Texas Instruments Incorporated

Re: Announcement #001
**Stellaris Flash Susceptibility to Power Cycling
Information Only**

Date: November 25, 2010

Announcement Number:	001.01 (follow-up)	Announcement Date:	11/25/2010
Title:	Tempest Device Derivatives: Flash Susceptibility to Power Cycling

Figure 1. V_{DDC} and V_{DD} Rise Time Relationships

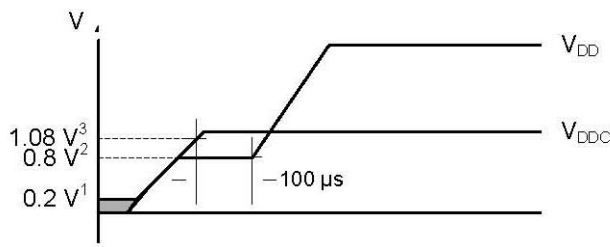
To eliminate the risk of flash corruption, two requirements must be met:

- The ramp of both V_{DD} and V_{DDC} must begin below 0.2 V
- V_{DDC} must reach 1.08 V at least 100 usec before V_{DD} rises from 0.8 V

A workaround circuit has been identified which meets these requirements and is described below. Figure 1 details these requirements and shows how the workaround circuit can meet them.

Note 1: Both V_{DD} and V_{DDC} must begin rising from below 0.2 V (200 mV). Note that even though power is not initially applied to the V_{DD} pins by the workaround circuit, the voltage applied to the V_{DDC} pins causes the V_{DD} voltage to rise along with V_{DDC} up to 0.8 V.

Note 2: With the workaround circuit, V_{DD} typically ramps to about 600 mV. V_{DD} must not exceed 800 mV at this stage.

Note 3: V_{DDC} must advance before V_{DD} ; once V_{DDC} reaches 1.08 V, 100 usec must pass before additional voltage is applied to V_{DD} .

Figure 2 shows a small chip-scale load switch to control V_{DD} . This circuit is suitable for V_{DD} current up to 2 A peak.

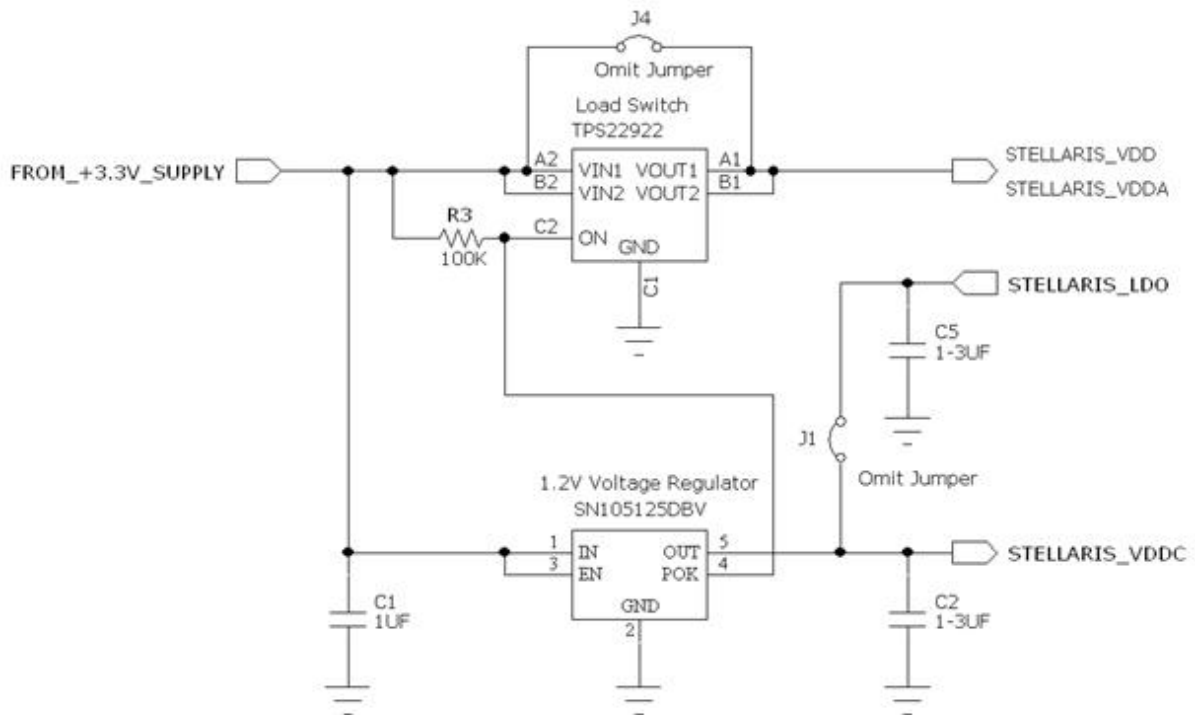
Two recommended circuits that eliminate the occurrence of this issue are shown below. Although the LDO regulator output is unused in the workaround circuit, a capacitor (1-3 μF) must remain connected for regulator stability. In addition, the LDO pin of the Stellaris device must be disconnected from the external 1.2 V LDO to prevent electronic over stress of the pin. Both of these circuits include two jumpers which provide the option to bypass the workaround circuit for future silicon revisions.
